**FIRESTONE ESTERO TOWN CENTER CPD**  
**Amendment to Commercial Planned Development**  
**Zoning Staff Report**  
**For Planning & Zoning Board Public Hearing**

<b>PROJECT NAME:</b>	<b>FIRESTONE - ESTERO TOWN CENTER CPD A PORTION OF TRACT A</b>
<b>CASE TYPE:</b>	<b>PLANNED DEVELOPMENT AMENDMENT</b>
<b>CASE NUMBER:</b>	<b>DCI2019-E005</b>
<b>PLANNING &amp; ZONING BOARD DATE:</b>	<b>August 18, 2020</b>

Figure 4 - Architectural Elevations

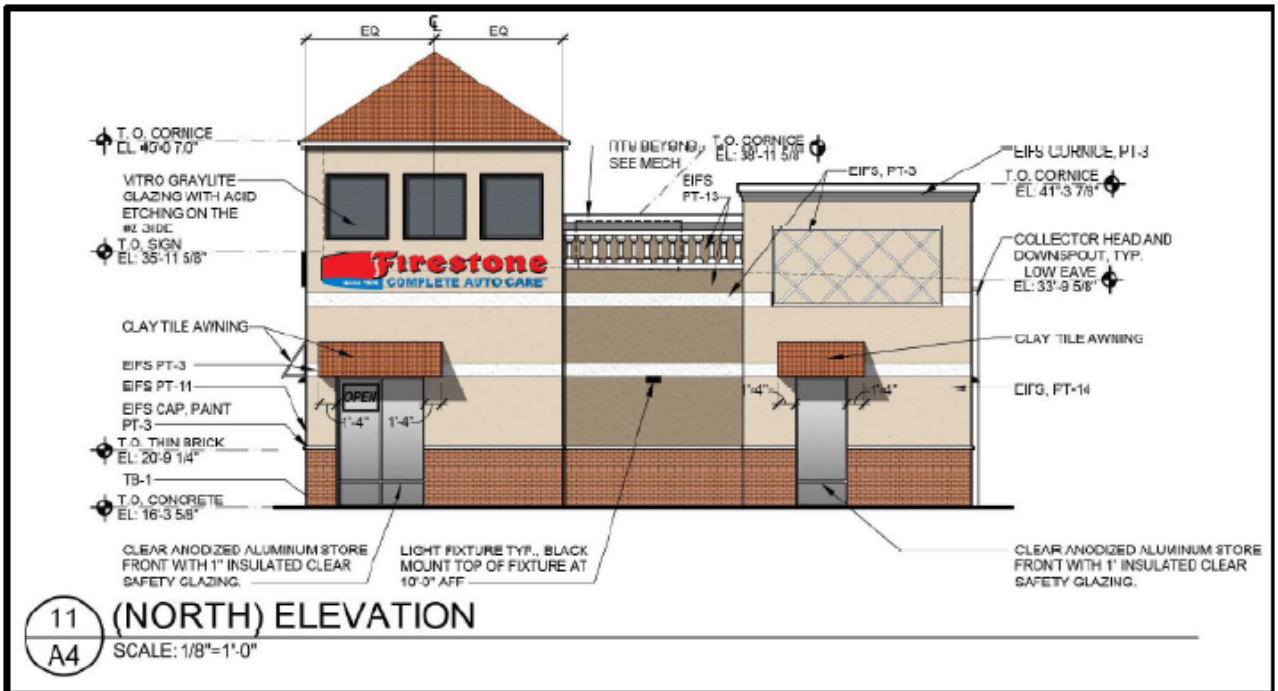
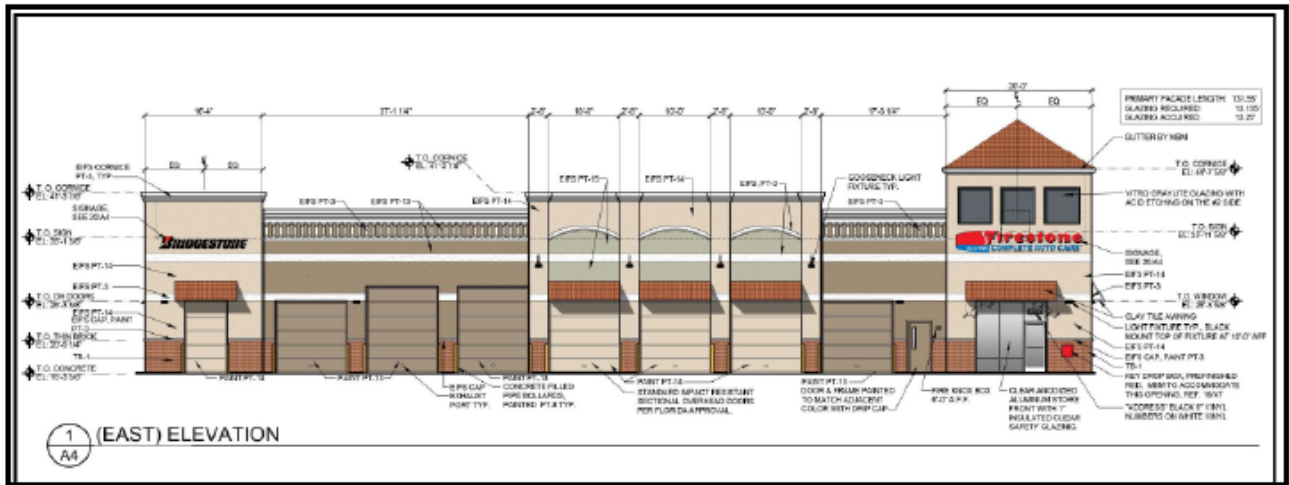
Building Elevations have been provided for all four sides of the building. A Mediterranean theme is used as shown in the figure below which shows the side of the building that will front on Corkscrew Road. Earth tones are proposed as well as clay tile awnings and other architectural elements. The garage bay doors are proposed to face east.

Figure 5 – Existing Tree Survey

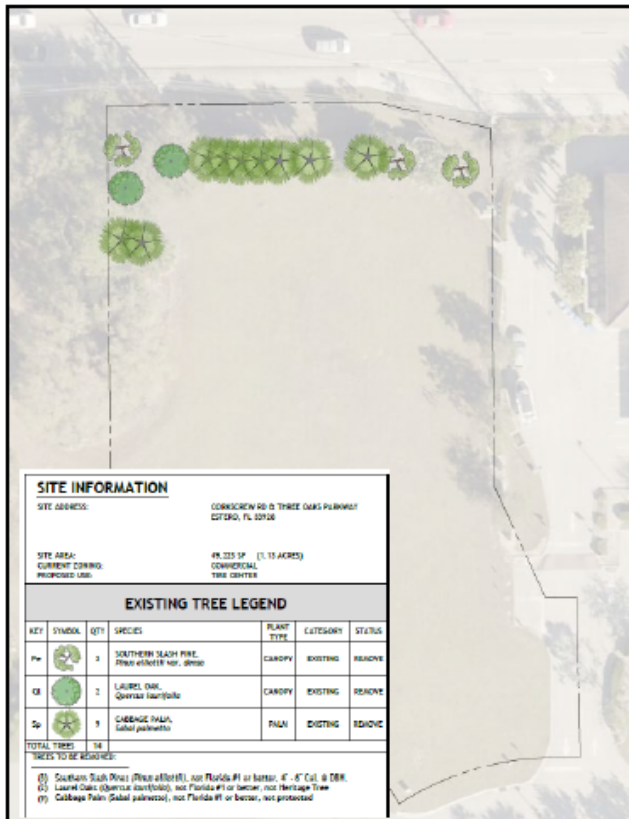
Most of the site is maintained as a mowed grassed lot with a group of native trees in the north area of the site along Corkscrew Road as shown in the figure, left. These trees are proposed to be removed.

# PEDESTRIAN SYSTEM

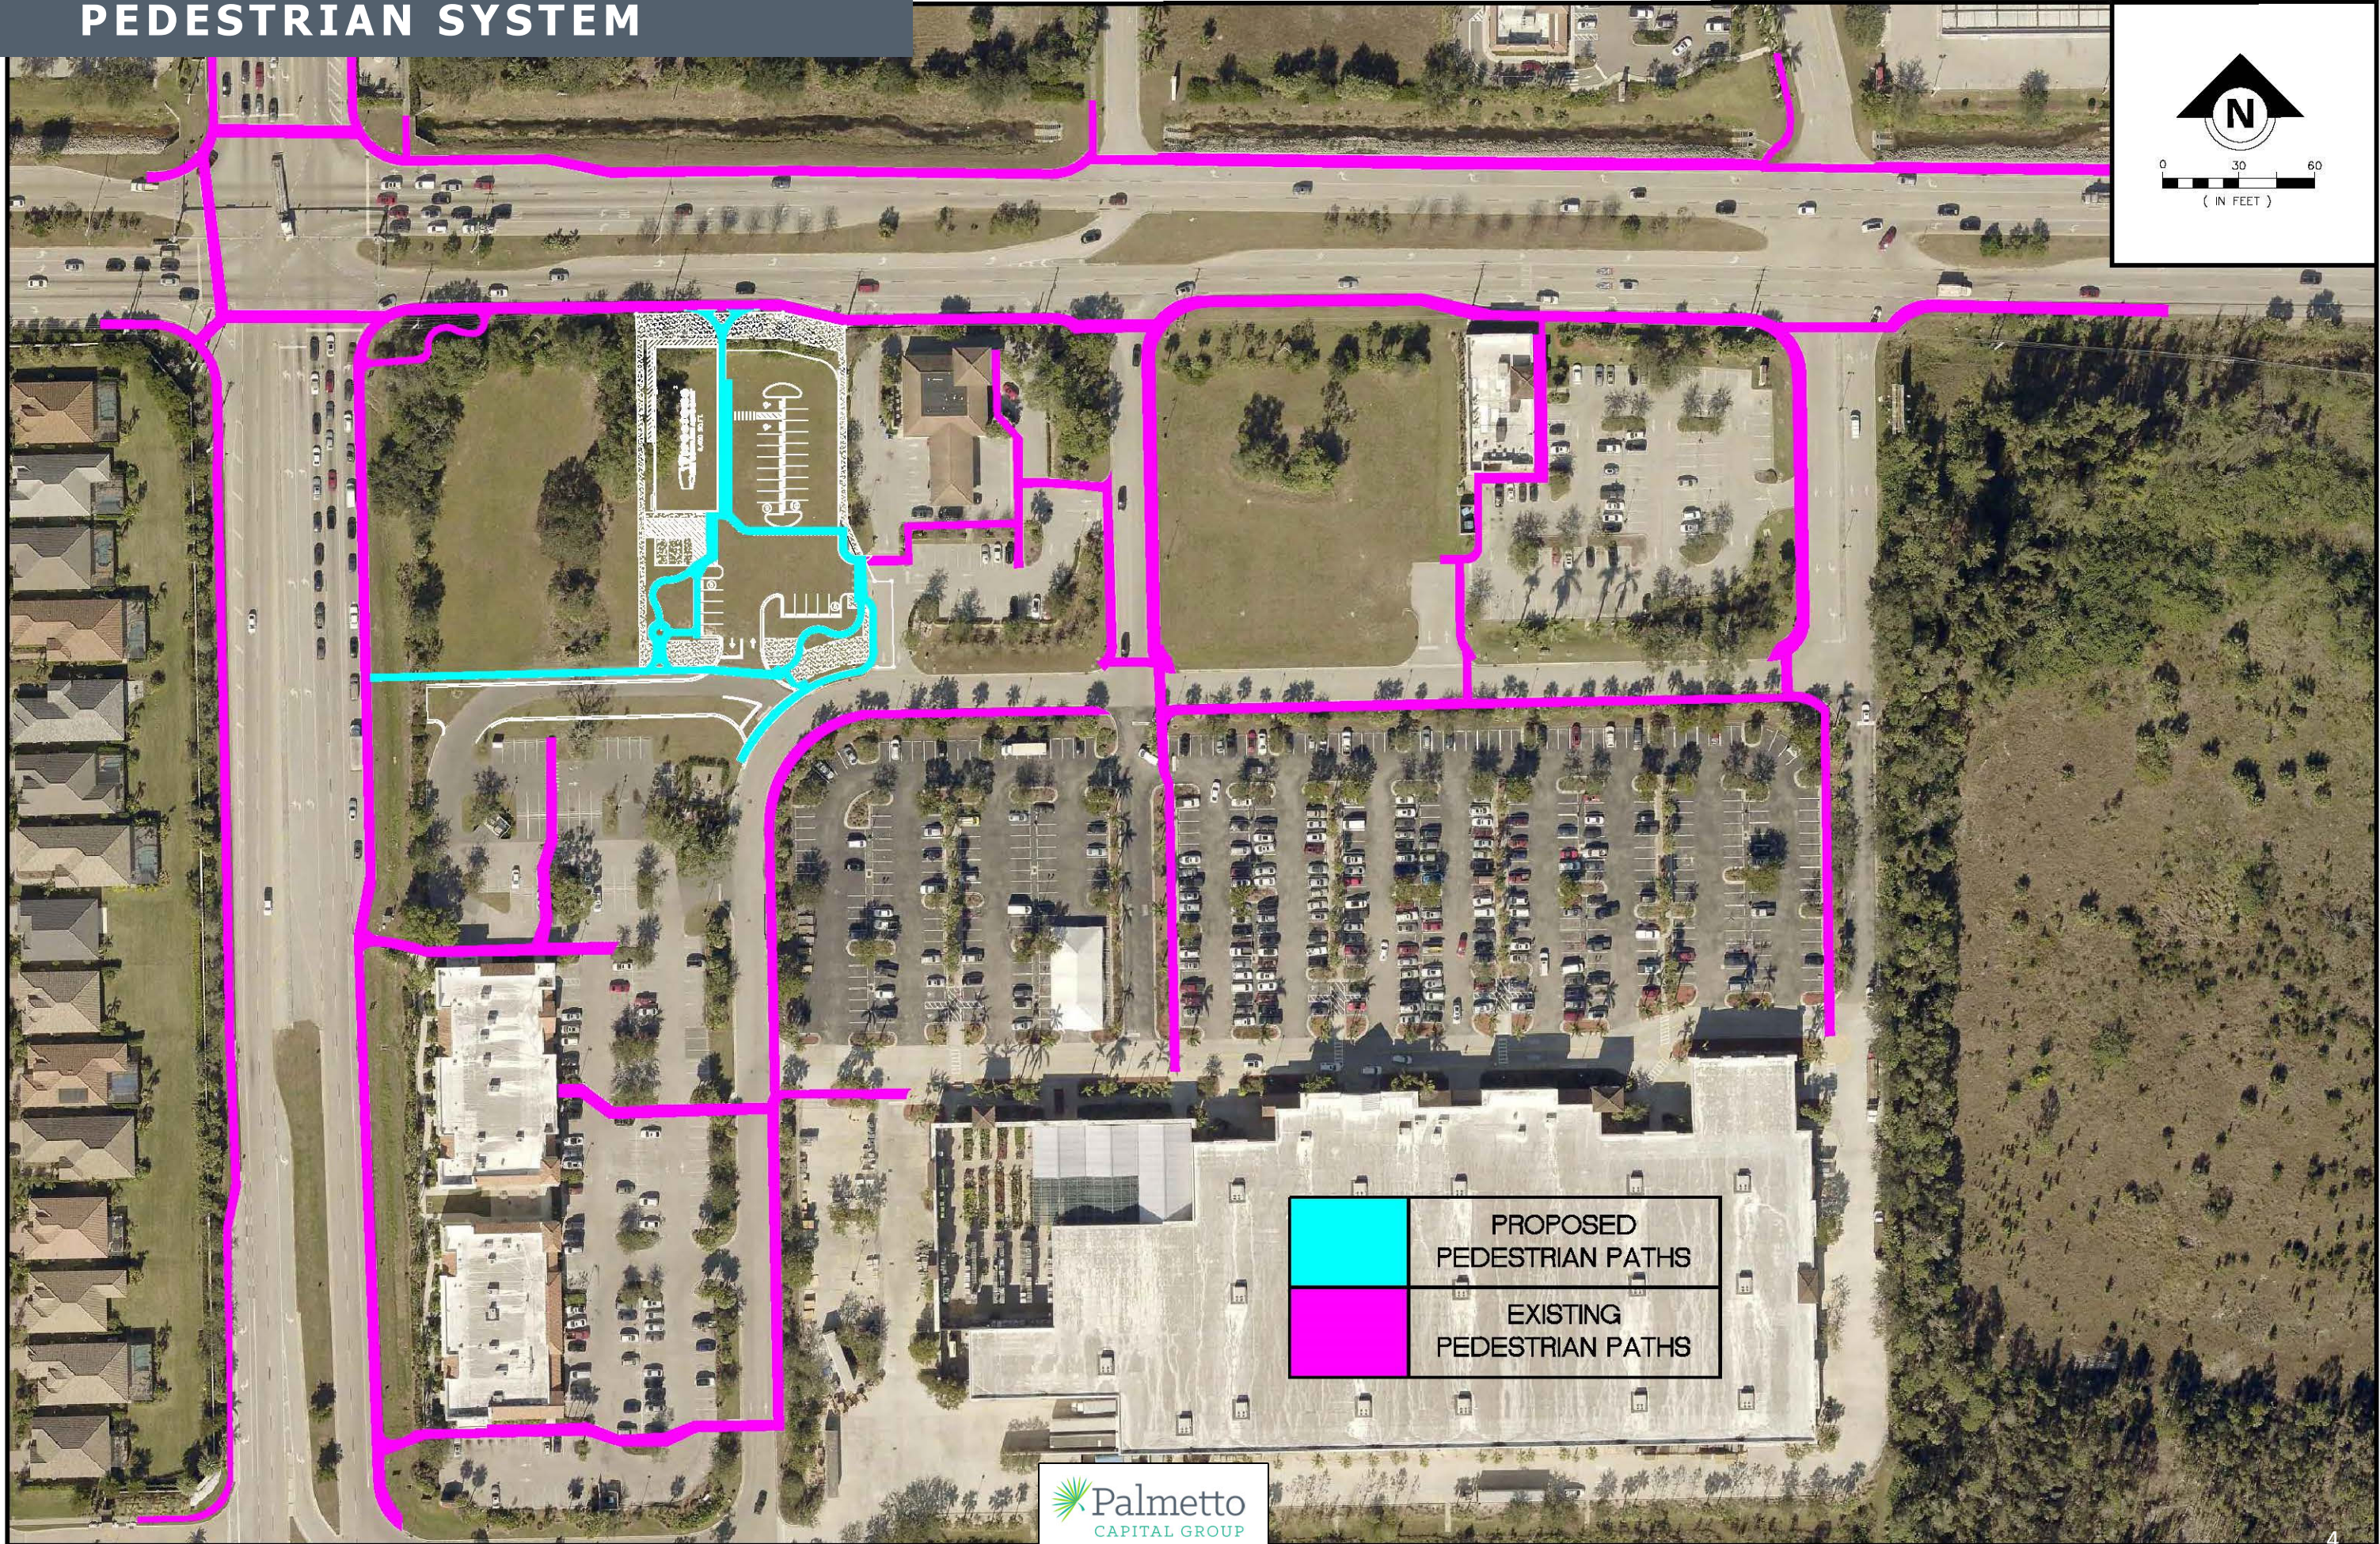
Staff Comment: The development has provided interconnections to the exterior of the development through a sidewalk connecting to Corkscrew Road and a sidewalk connecting to Three Oaks Parkway. Numerous interconnections occur within the interior of the development as well. See Figure 3 for map of existing and proposed pedestrian connections.
